CITY OF WISCONSIN DELLS MEETING AGENDA

Meeting Description DESIGN REVIEW COMMITTEE

Date: WEDNESDAY, APRIL 5, 2017 Time: 10:00AM Location: MUNICIPAL BUILDING - 300 LA CROSSE STREET, WISCONSIN DELLS, WI

DRC 04/05/17

Item 3(a) Pepper Palace – 304 Broadway

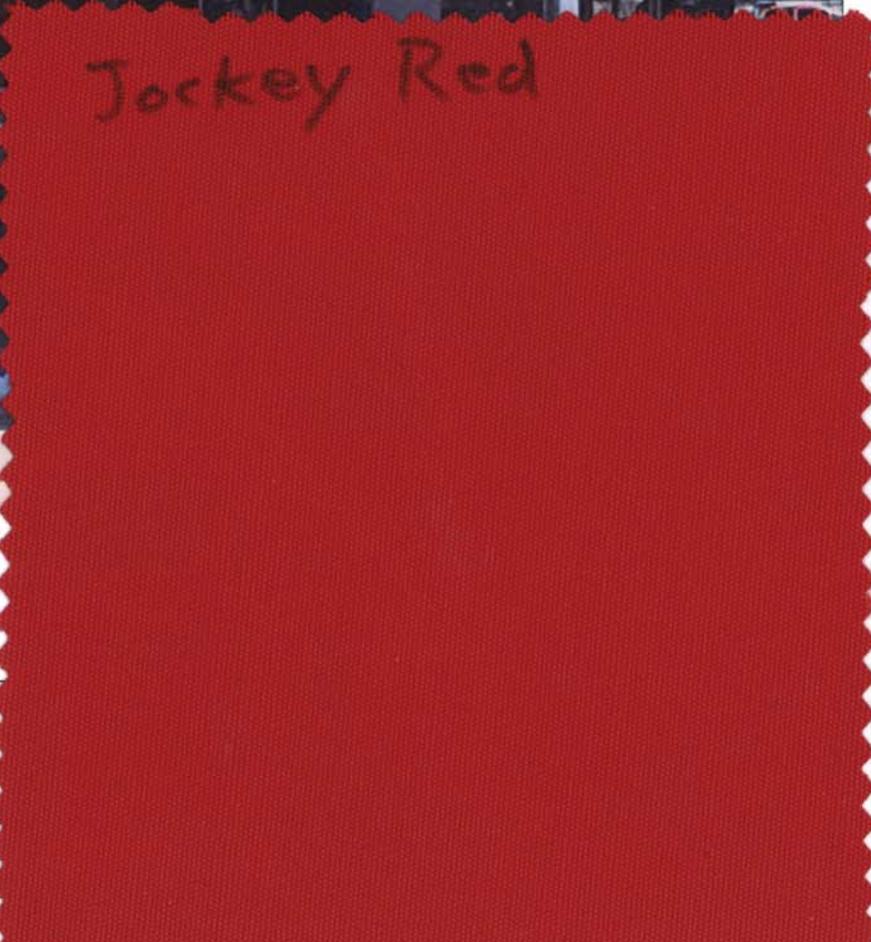
This building is approximately 20 ft wide, which would allow a total of 100 sq ft of signage, so the minimum of 144 sq ft of signage is allowed.

The top of the awning is approximately 5.9 ft wide for a total awning face area 118 sq ft, 50% of which allows 59 sq ft of signage. The signage is approximately 39 sq ft, so the size meets the Design Standard requirements.

It appears the main items on this request of if the awning color relates to and complements the primary color of the building façade and /or if the awning color is too bright.

The applicant has stated that the red color is vital to their brand as a business selling hot sauce, and that “Other colors like Terra cotta or brown do not say, “Hot Sauce.””

Terra cotta is the designated color for the 00 block.

The applicant had stated the owner may paint the building so that it more complements the colors of the awning, but that would be something they would have to do in the future for financial reasons.

Item 3(b) River Dawg – 808 River Rd

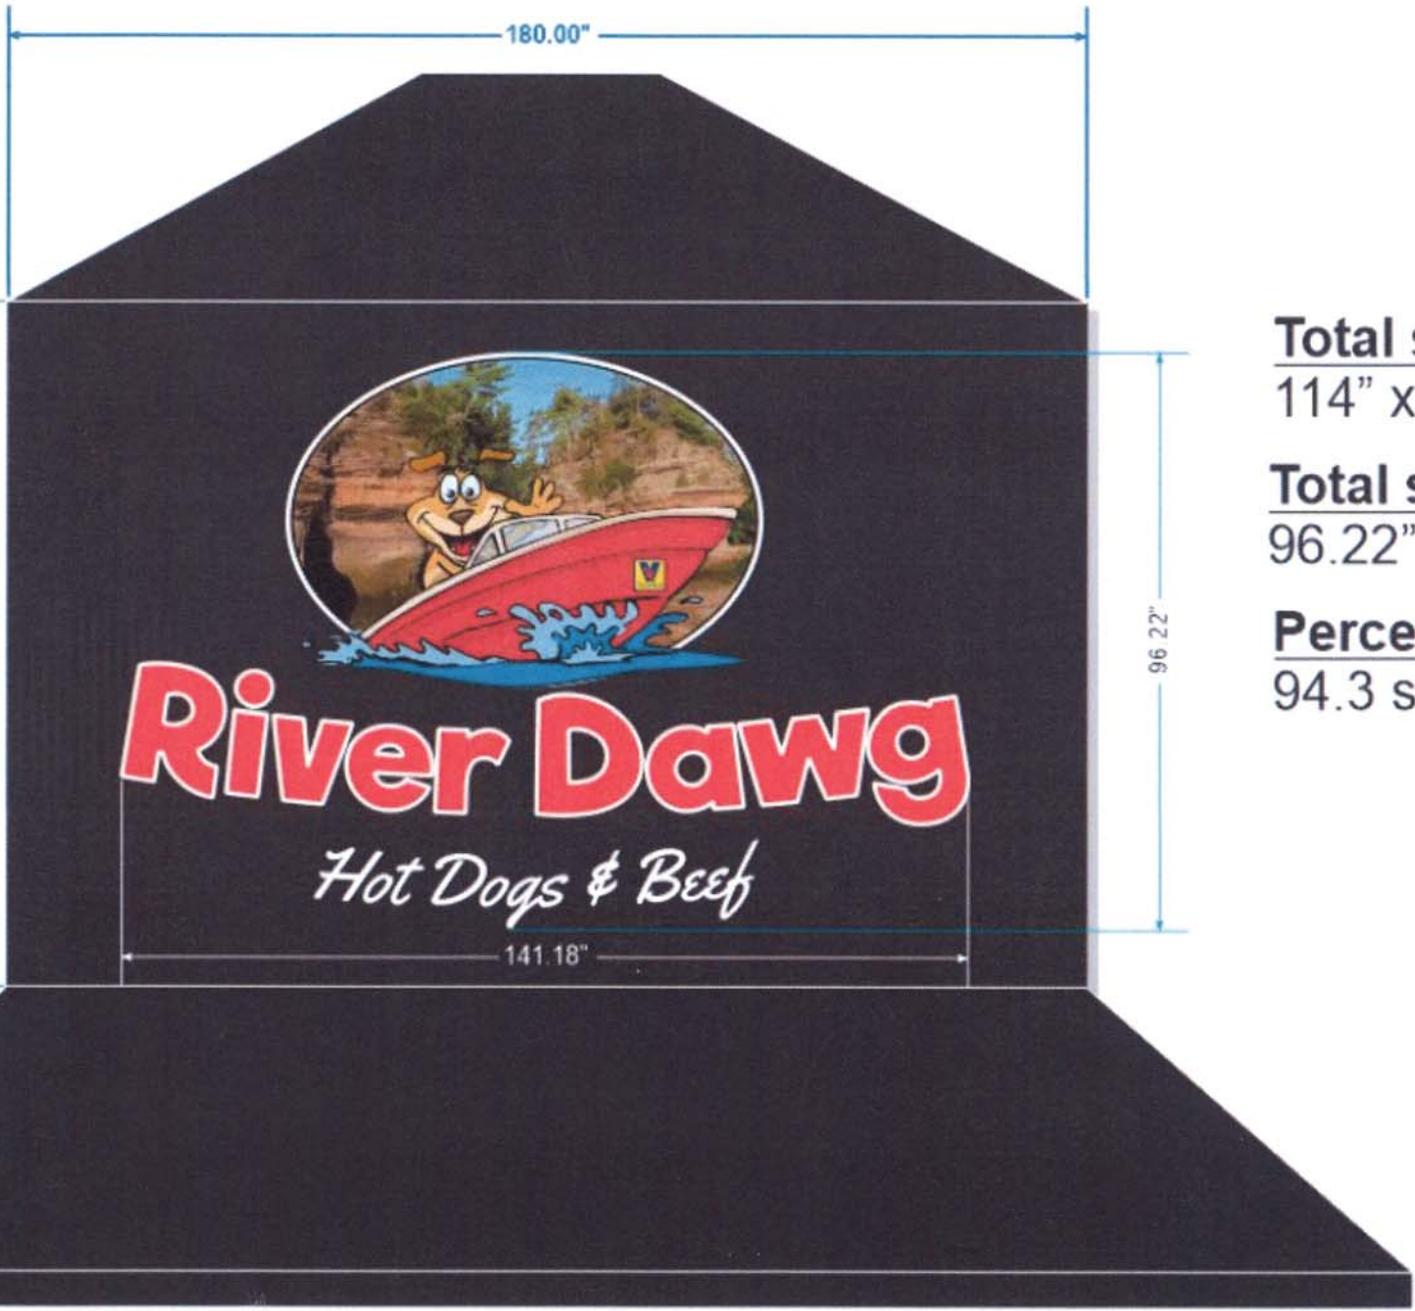
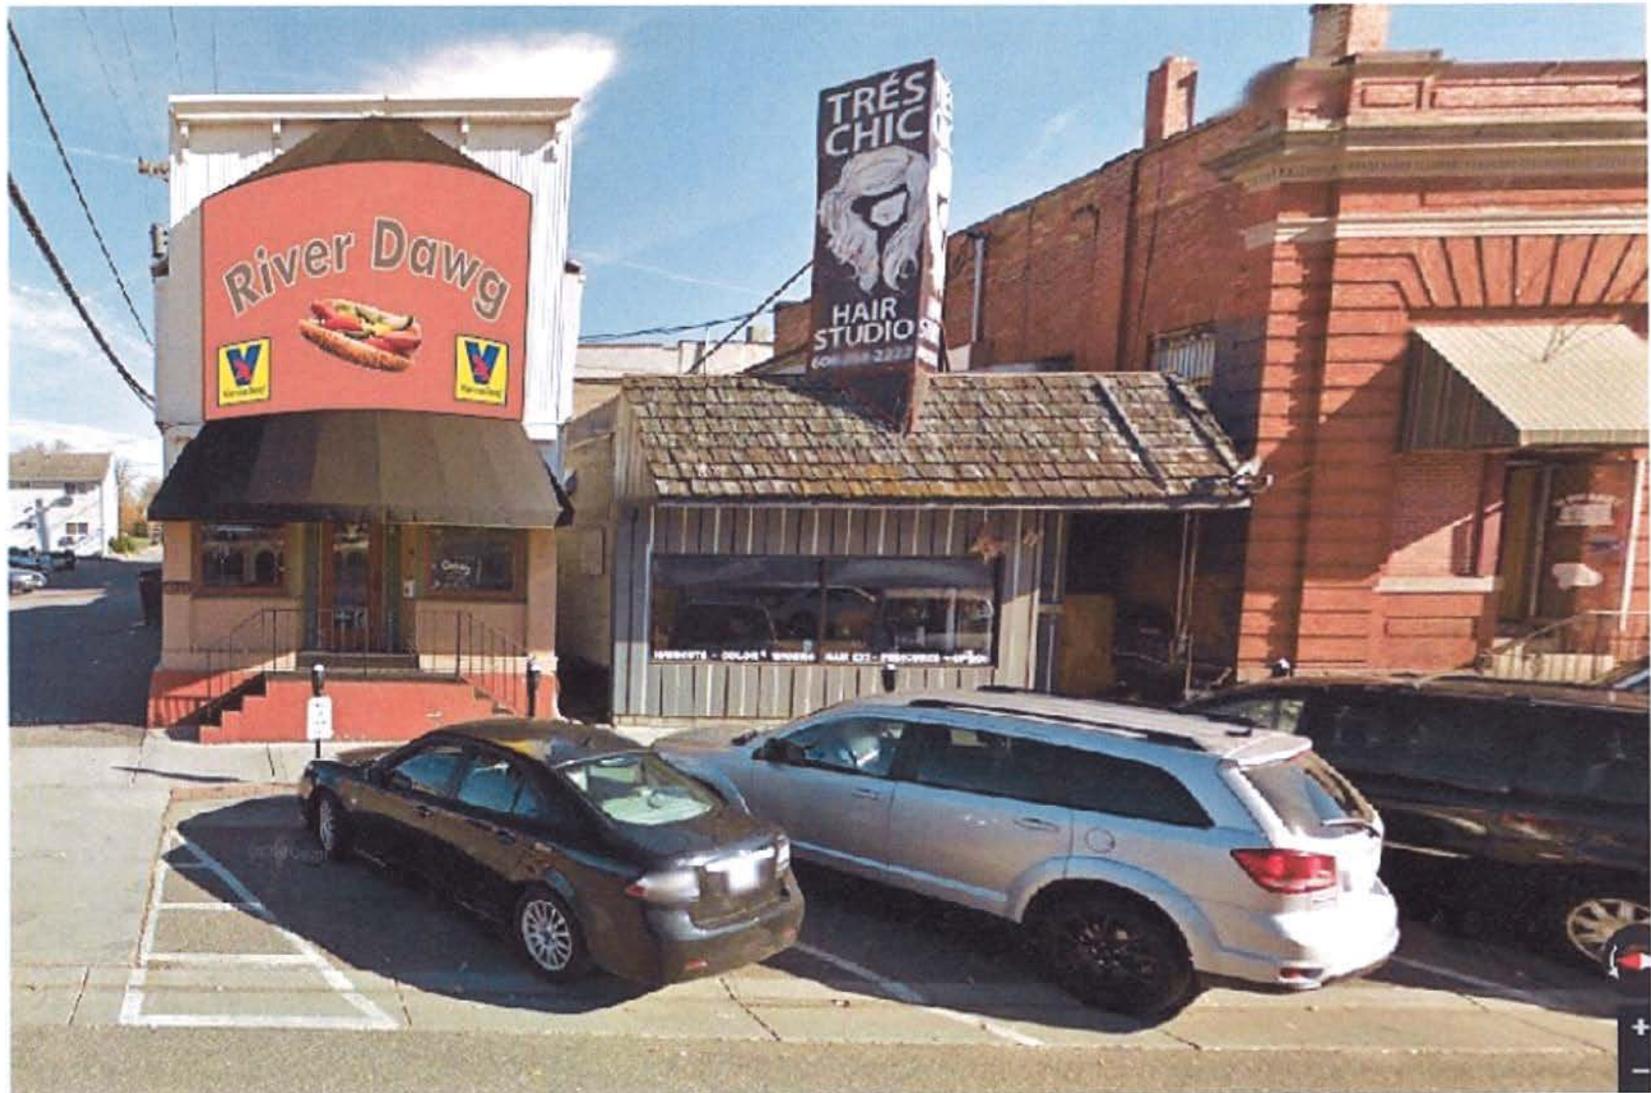
The front of the awning is approximately 15 ft wide and 9.5 ft high, for a total awning face area 143 sq ft, 75% of which allows 106 sq ft of signage. The original signage is approximately 111 sq ft, so the size does not meet the Design Standard requirements. The applicant was going to remove the Vienna Beef logos from the signage and reduce the “River Dawg” lettering to meet the 75% signage requirement.

It appears questionable that this awning relates to and complements the primary color of the building façade.

This sign currently has internal illumination which is now prohibited. Any approval of this request would be contingent on the signage meeting the 75% requirement, the internal illumination being removed, and the committee approval that the awning compliments the primary color of the building façade.

This request also highlights the fact that there is currently no standard for how the awning size itself relates to the building. The current standards only require the awning project between 3 and 6 feet from the building and provide 8 ft of clearance over the sidewalk. However, this awning does not appear to be anywhere near the size and style the that would be preferred.

Item 3(c) Maurer’s billboard – 601 Broadway

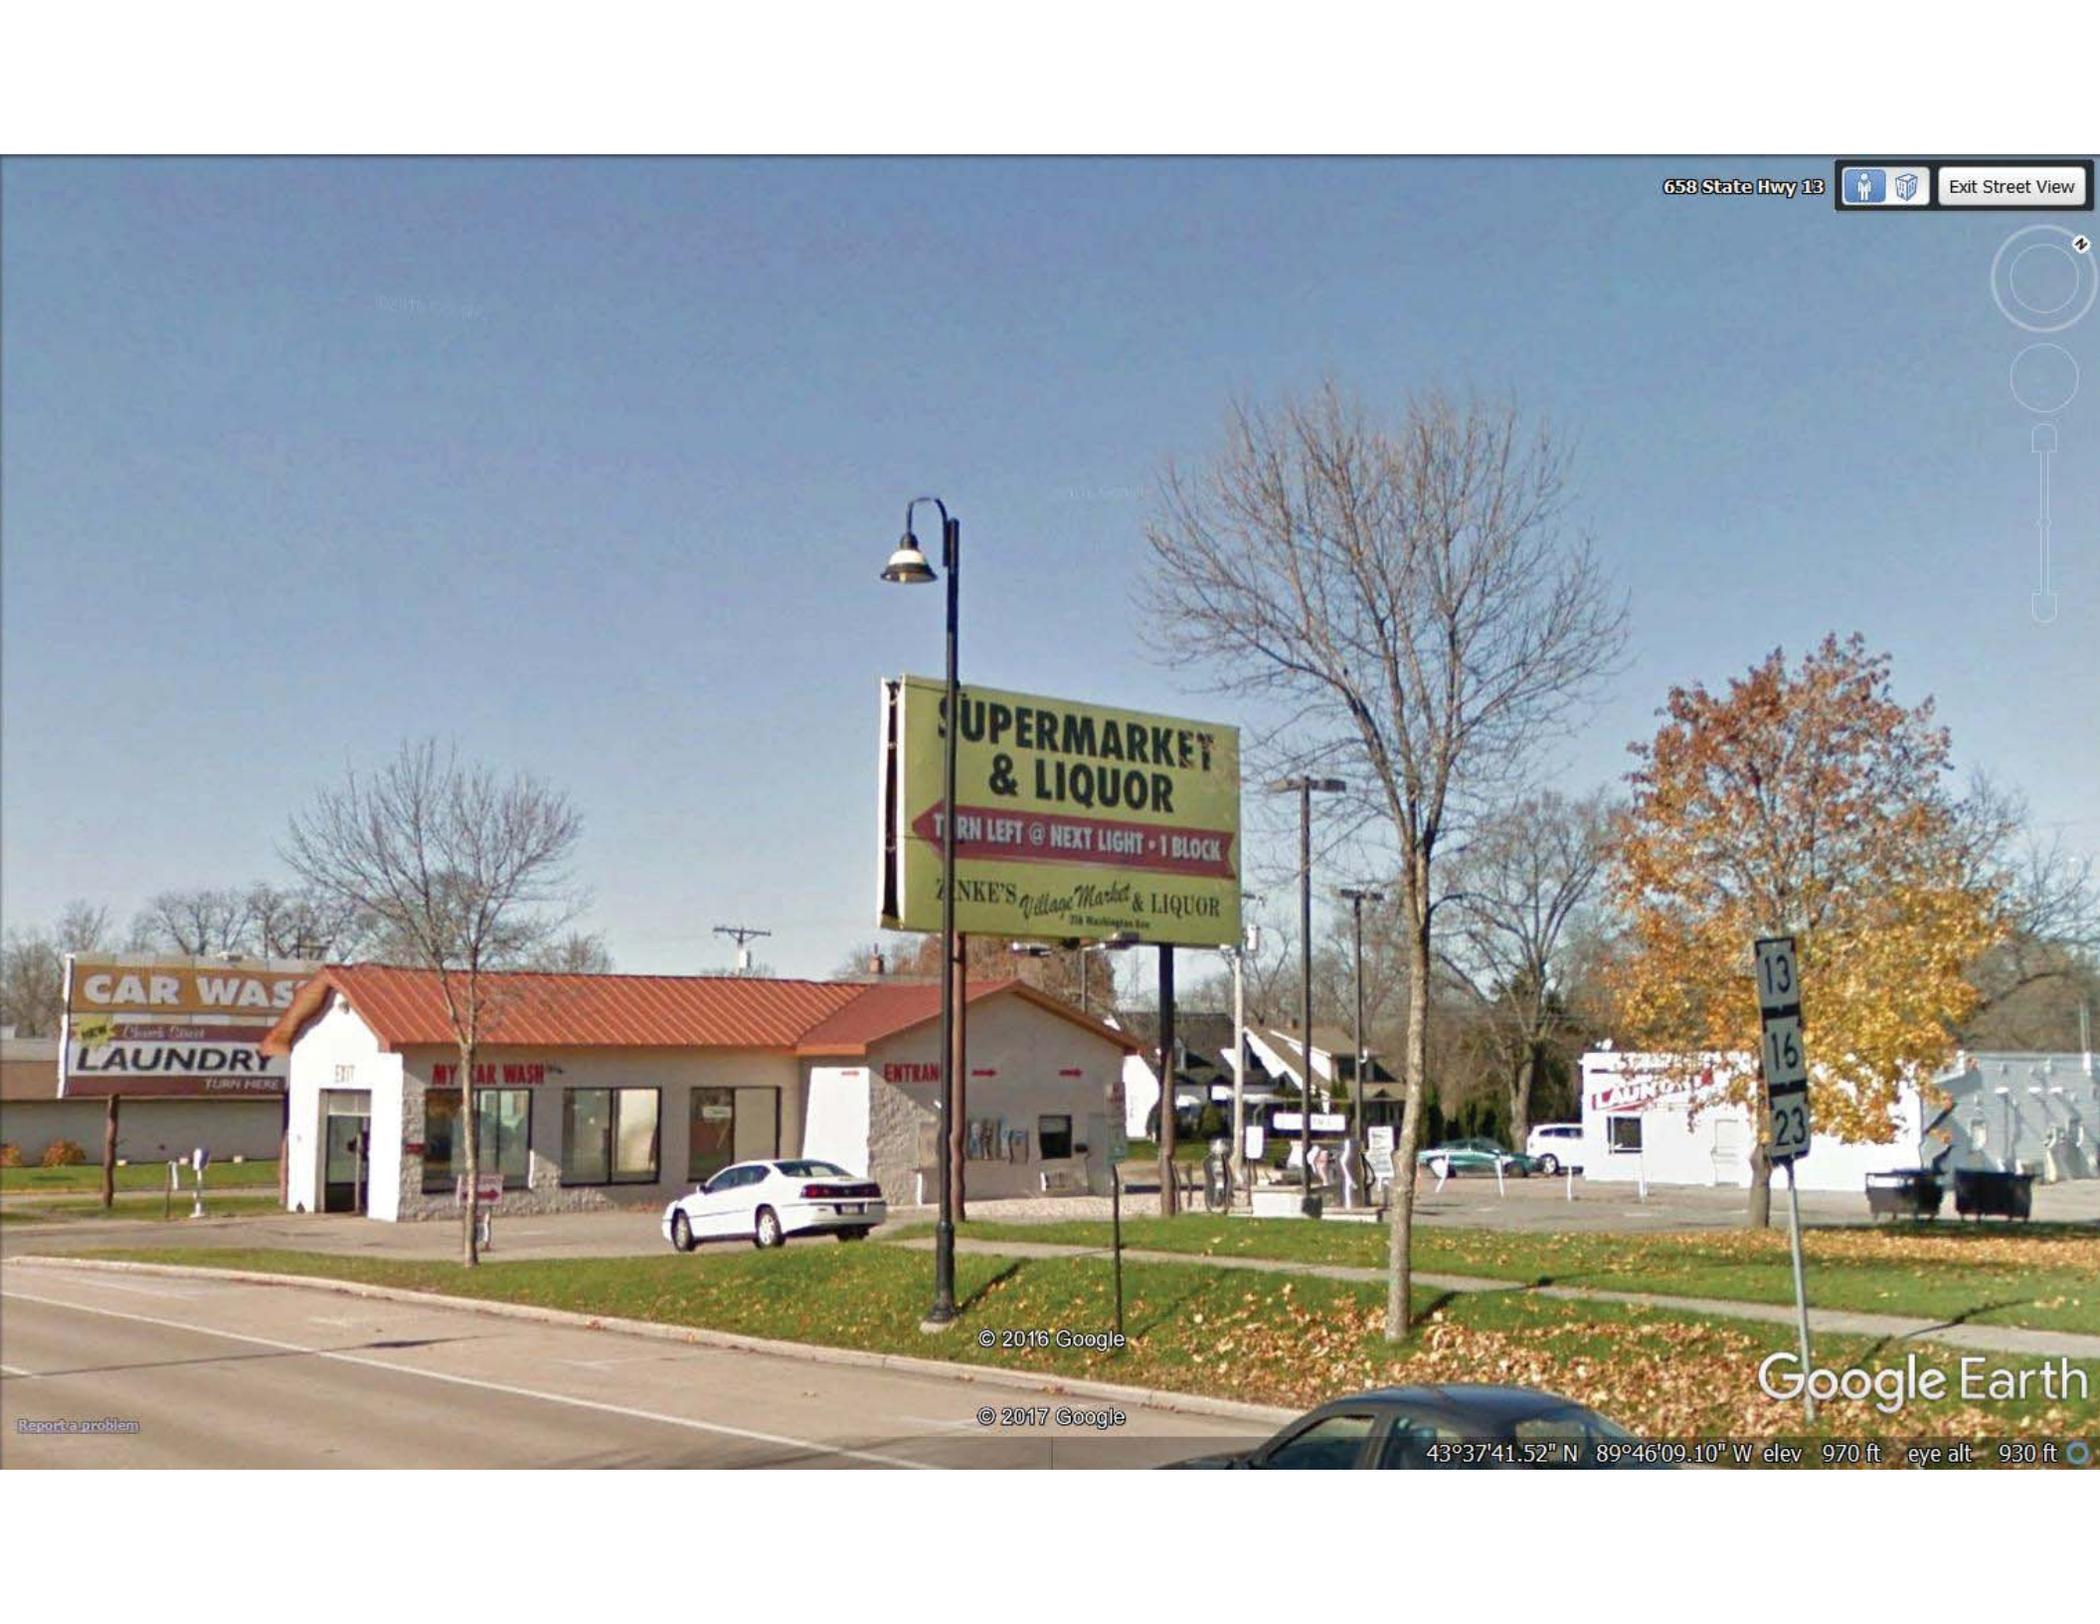
This is a 24’x12’ vinyl billboard wrap. As an off-premise billboard sign, this is considered legal non-conforming. As these types of signs are no longer permitted the new Design standards do not address them specifically.

I believe the committee will have to review these signs on general design aesthetics.
